# Service Bulletin SBA0292

Aqua Hot control thermostat update and shelf stock replacement information

Title: **Part Replacement**

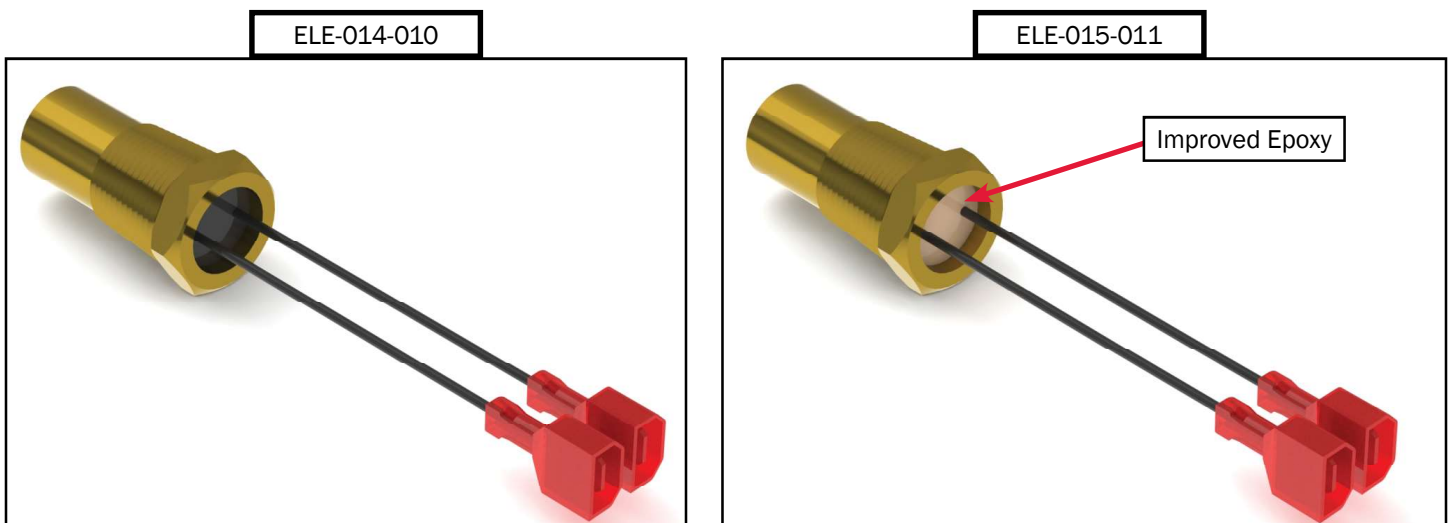
Aqua-Hot is consistently working to improve the quality and experience of our consumers. Aqua-Hot has determined that we have had a higher than normal failure rate on the ELE-014-010 Control Thermostat in the 250D and 250P Series of hydronic heating systems. We have worked with our suppliers to identify the failure cause and have redesigned this part to eliminate these occurrences.

On March 8, 2021, Aqua-Hot implemented a change to the epoxy that seals the switch inside the control thermostat. All Aqua-Hot 250 Systems built on and after that date have this change and all parts orders from that date forward will have this improved epoxy as well.

The old part number, ELE-014-010 (with black epoxy), is now replaced with part number ELE-015-011 (with tan epoxy):

Any Aqua-Hot 250D and 250P models in the field that experiences a failure with the control thermostat should replace it with the new part, ELE-015-011, (fix as fail).
